# PERMIT

## SEWAGE DISPOSAL SYSTEM

HOWARD COUNTY HEALTH DEPARTMENT  
BUREAU OF ENVIRONMENTAL HEALTH

LOCATION SURVEY  
 16190 A.E. MULLINIX RD.  
 HOWARD COUNTY, MD.

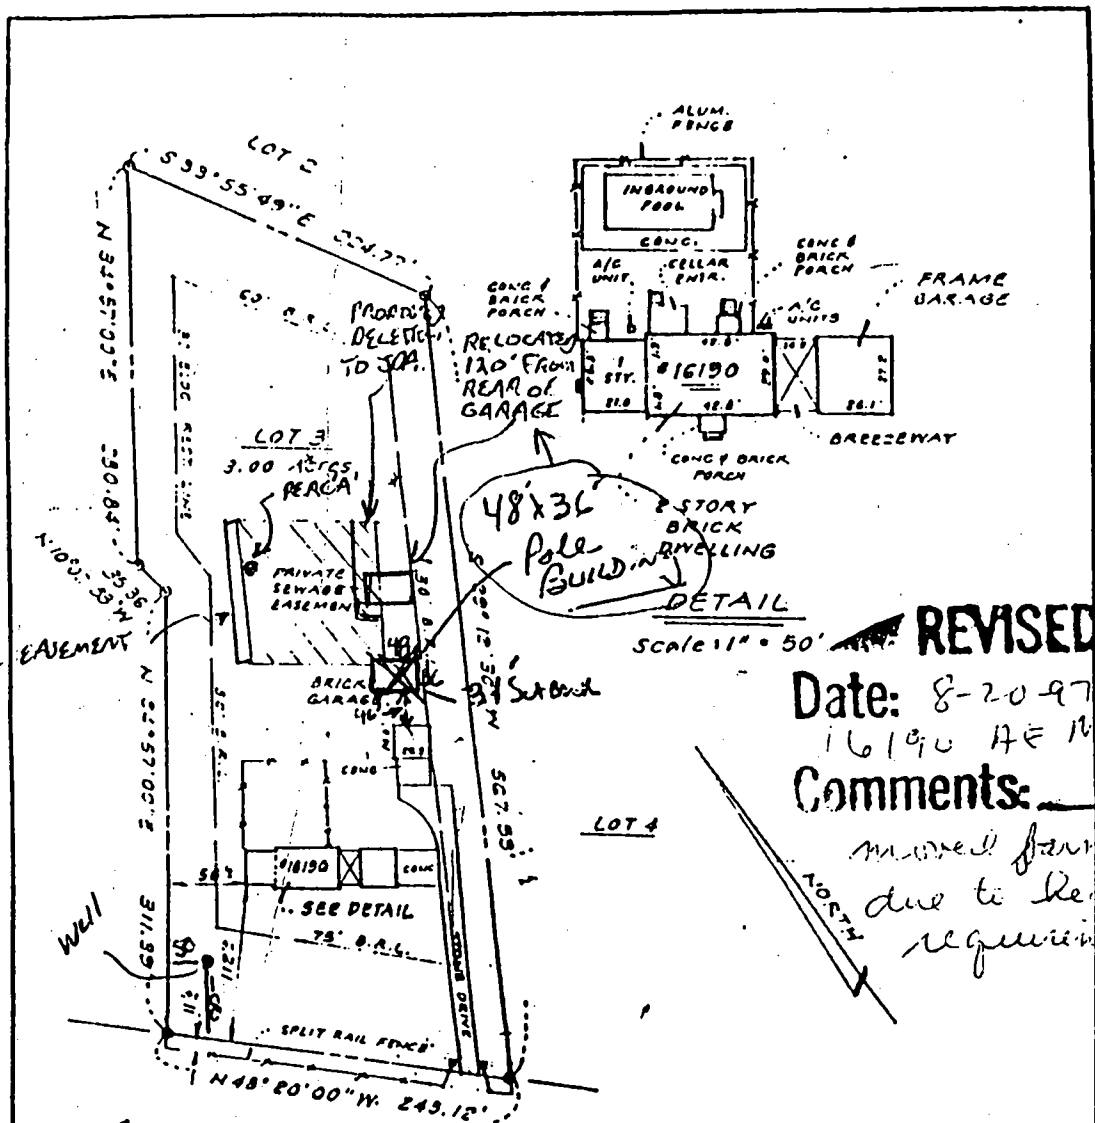
PROPOSED ADDITION TO SEPT

REVISED

Date: 8-20-97  
 16190 A.E. MULLINIX RD  
 Comments: 1300156724  
 moved front back  
 due to health dept  
 requirement

2/15/97 PROPOSED  
 AMENDMENT PREPARED  
 AS SHOWN Bladys R.S.  
 BY COPY OF THIS APPROVED PLAN  
 THE HEALTH DEPARTMENT ALLEYS  
 THE PROPOSED MODIFICATION TO  
 THE SEPTIL EASEMENT.  
 8/20/97 Bladys R.S.

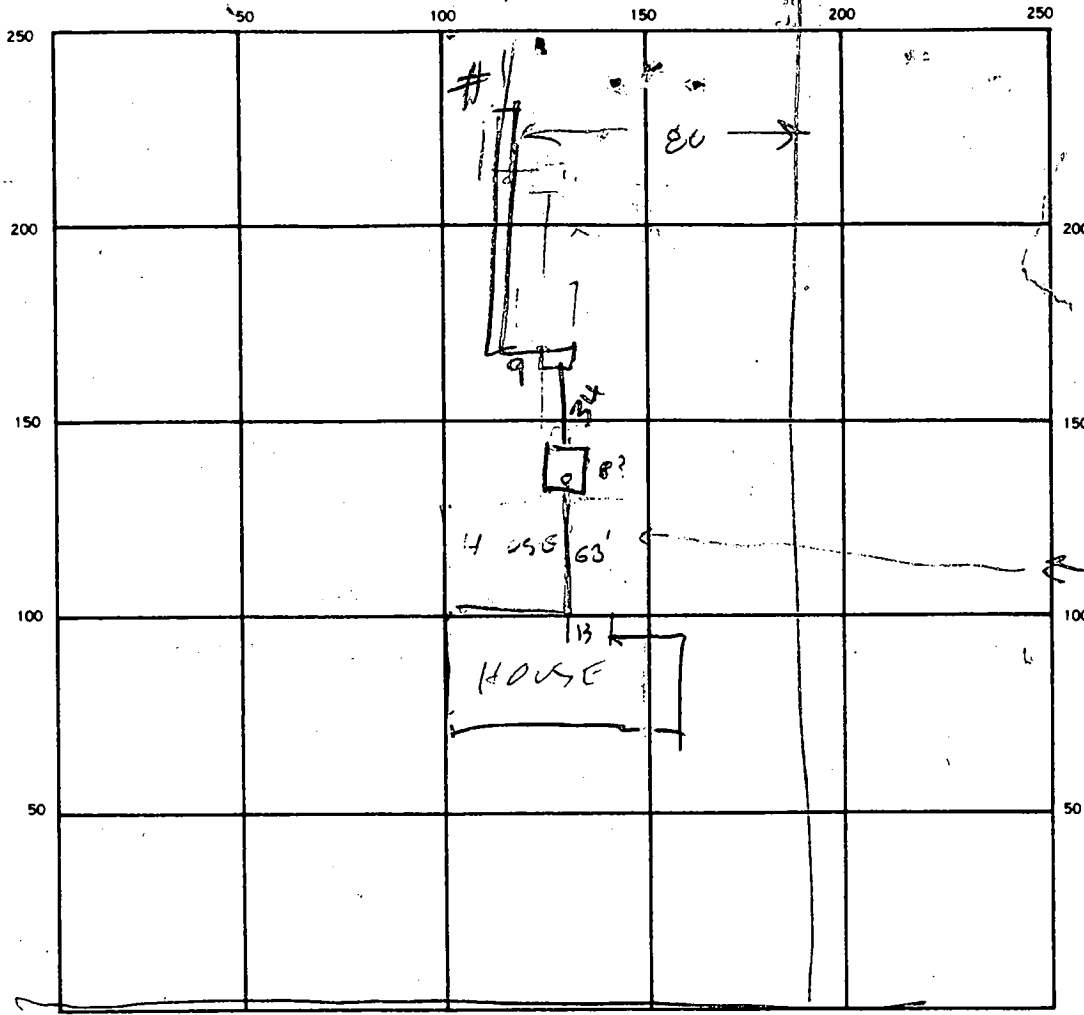
5/3/91  
 (?) on these  
 measurements  
 C.H.

LOT#3  
HENDERSON PROPERTY  
OF A. E. MULLINIX  
ROAD, LOTS 1 THRU 4  
PLAT-4698

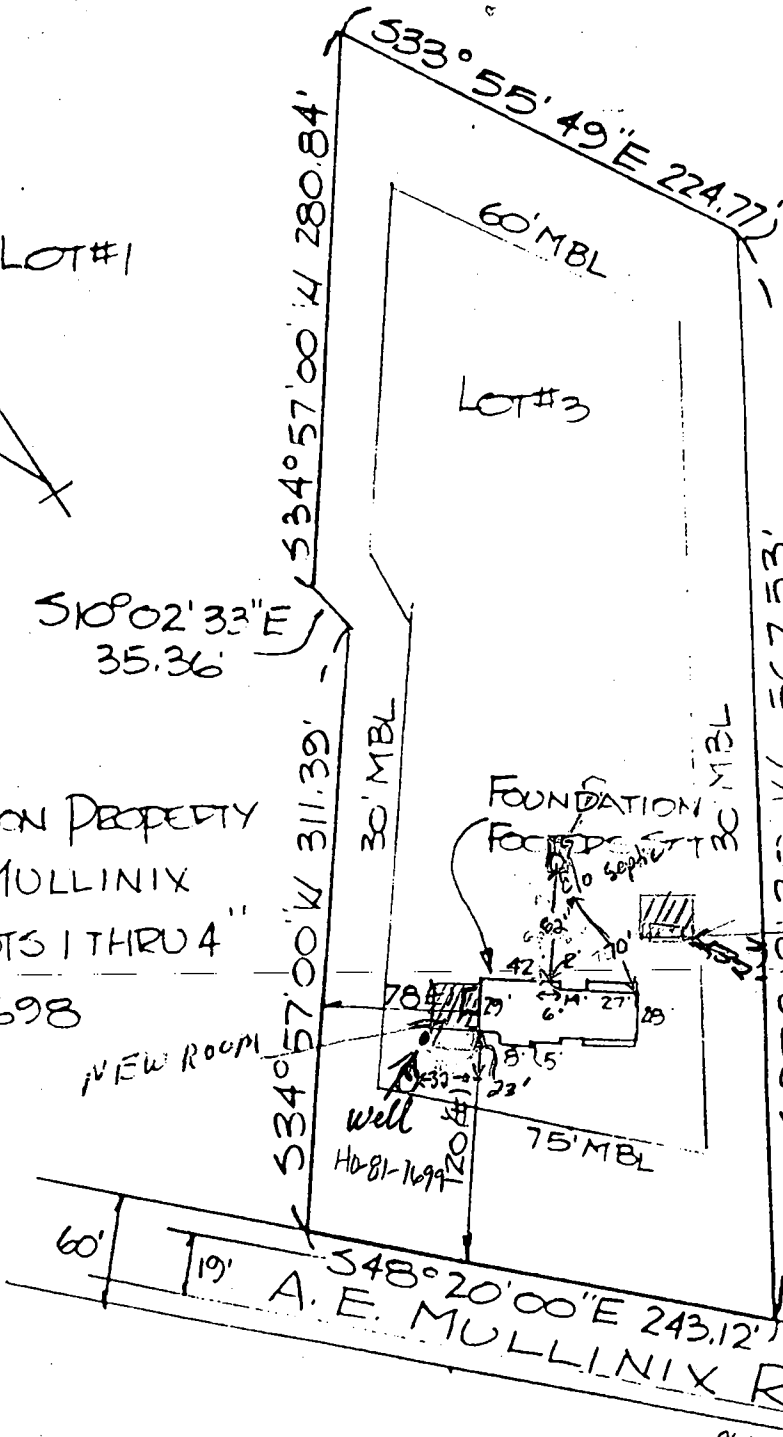
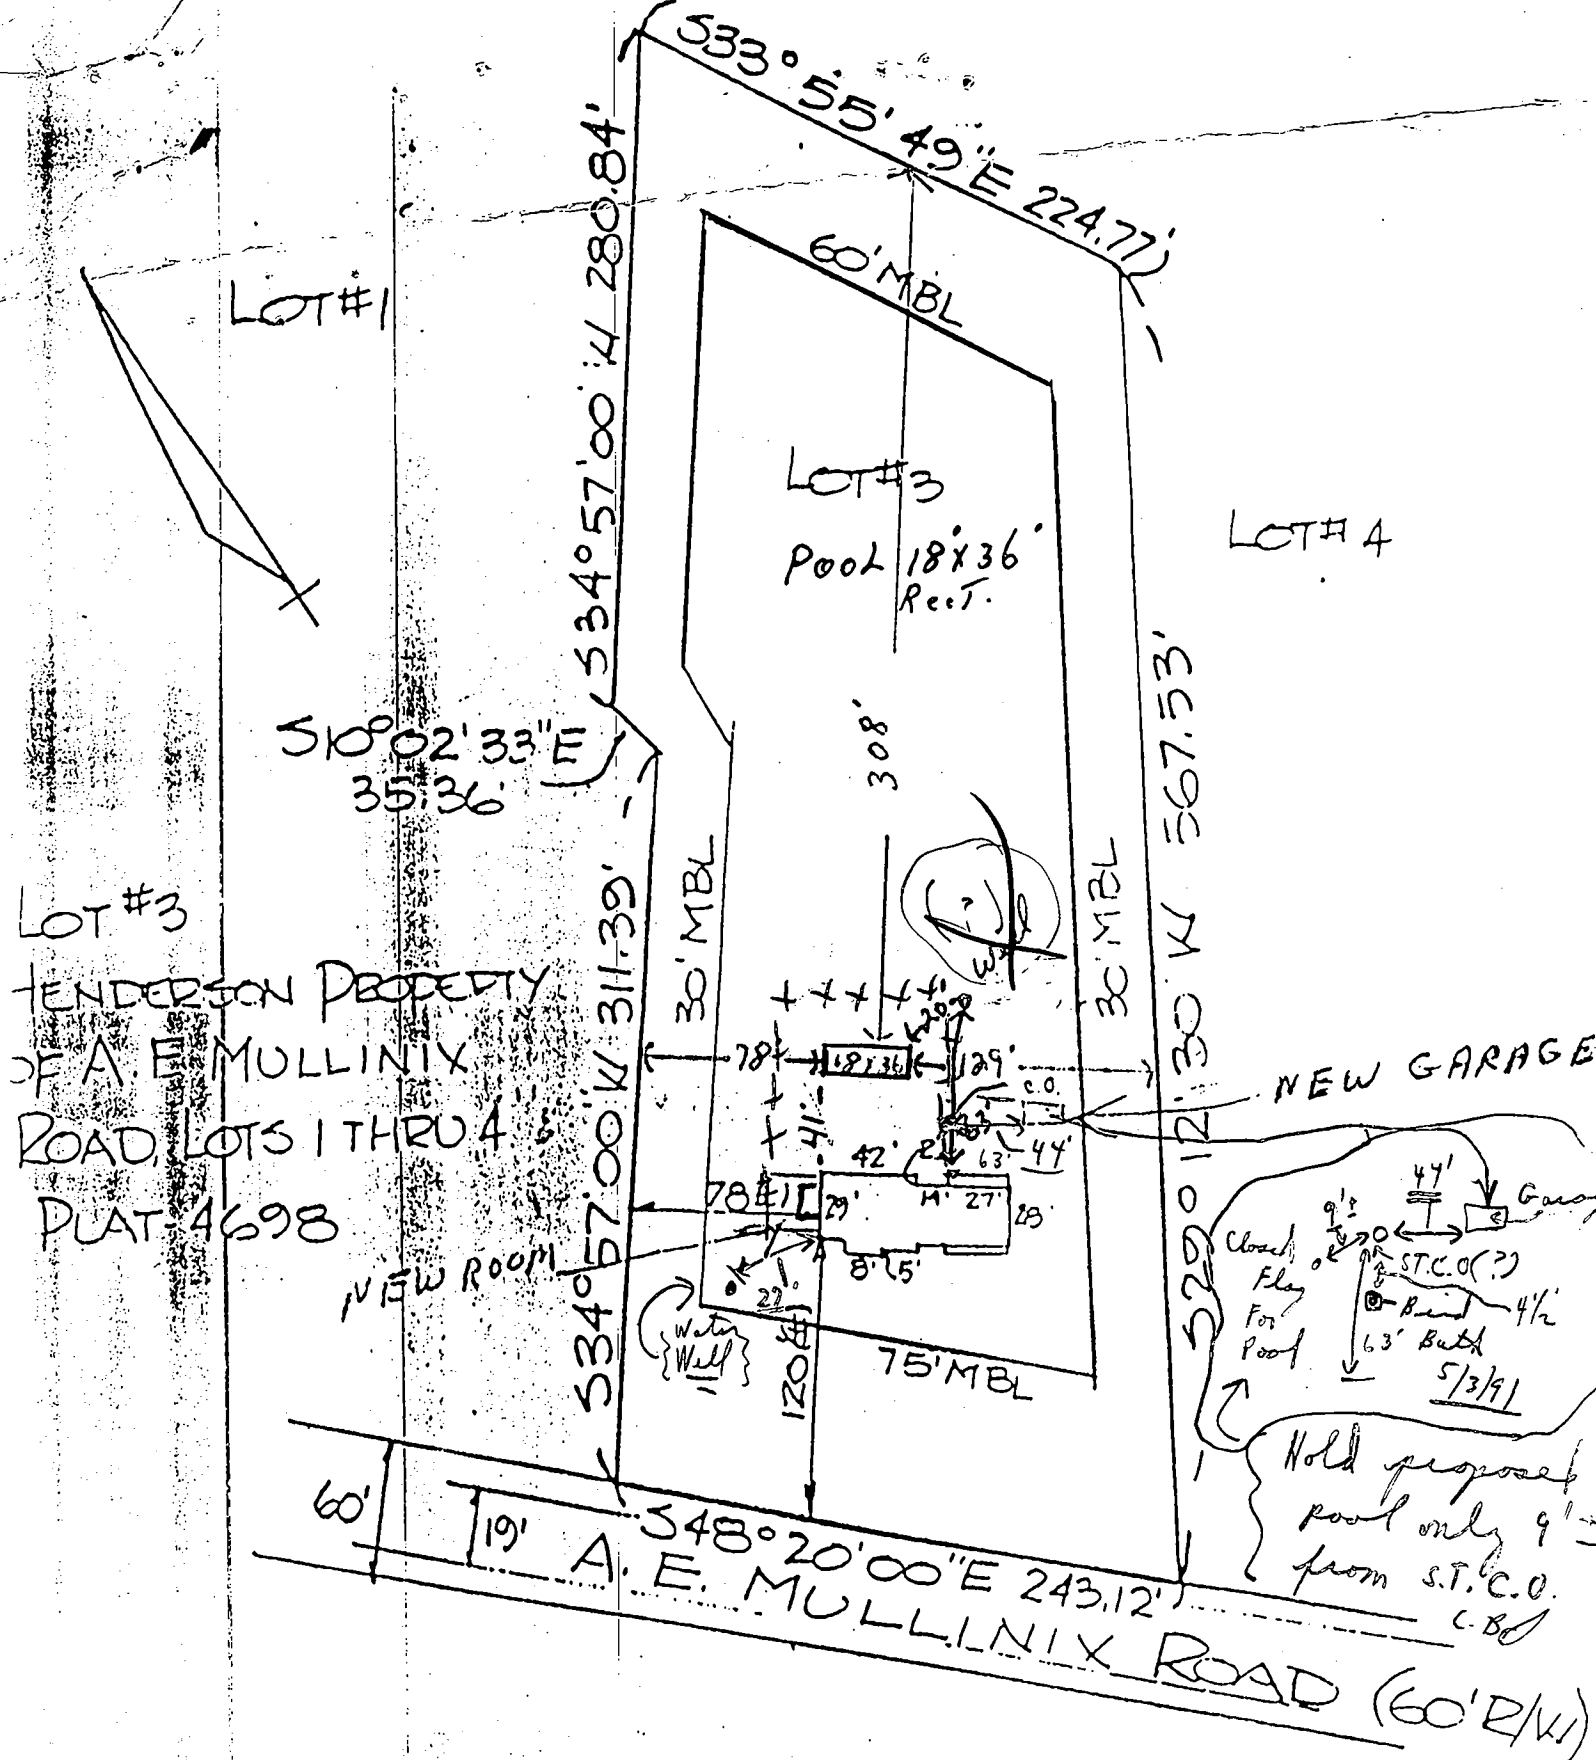
2-23-89 well is 32 ft off the left side of the house. The proposed addition would be about 20 ft from the well. septic tank was outlined w/ lush green LOT# 4 grass. some dark organic matter at side of cleanout in bare spot. Possibly residue from pumping tank. water in tank was about 6 inches below the top. No overflow observed. Unclear of exact location of proposed garage. Need more information

2/24/89 PER OWNERS  
GARAGE TO BE  
AT LEAST 30' FROM  
SEPTIC / ADDITION  
TO BE 27' FROM  
WELL; I INDICATED  
CONSENT & SUGGESTED  
HE ADJUST ADDITION TO  
30' FROM WELL  
IF POSSIBLE.

OWNER HAS BEEN HEAVILY USING RIDEX<sup>®</sup> ON HIS SEPTIC SYSTEM WHICH MAY HAVE CAUSED CONDITION OBSERVED. HE WILL HAVE TANK PUMPED AND DISINFECTED.

OK TO PROCEED WITH BP.  
LIBER 1557 / FOLIO 476  
HOWARD COUNTY, MD
